Ref: EN010132

Date: 6th December 2024

**APPLICATION BY WEST BURTON SOLAR PROJECT LIMITED (“THE APPLICANT”) FOR AN ORDER GRANTING DEVELOPMENT CONSENT FOR THE PROPOSED WEST BURTON SOLAR PROJECT**

Lincolnshire County Council (LCC) has reviewed the additional information provided and has the following comments to make in respect of the further information submitted regarding the option to remove solar panels from Stow Park Deer Park (“the Stow Park Alteration”), and in relation to archaeology the Outline Decommissioning Statement

Figure 8.18.3: Landscape and Ecology Mitigation and Enhancement Measures Revision B

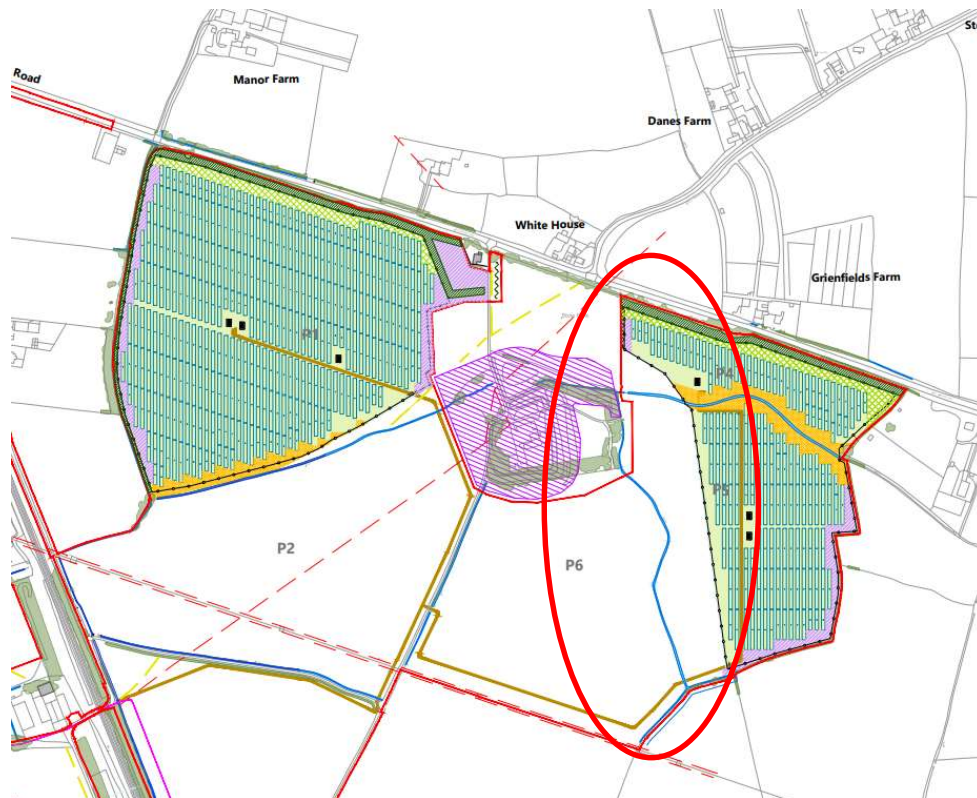
Please note there appears to be a discrepancy on the area of the Deer Park shown under solar panels between the updated Environmental Statement Figure 8.18.3: Landscape and Ecology Mitigation and Enhancement Measures Revision B and the maps shown in the ES

Appendix 9.12 BNG Report Revision A. The western side of the most eastern block of panels in WB3 appears differ. The applicant should clarify the area which is correct.
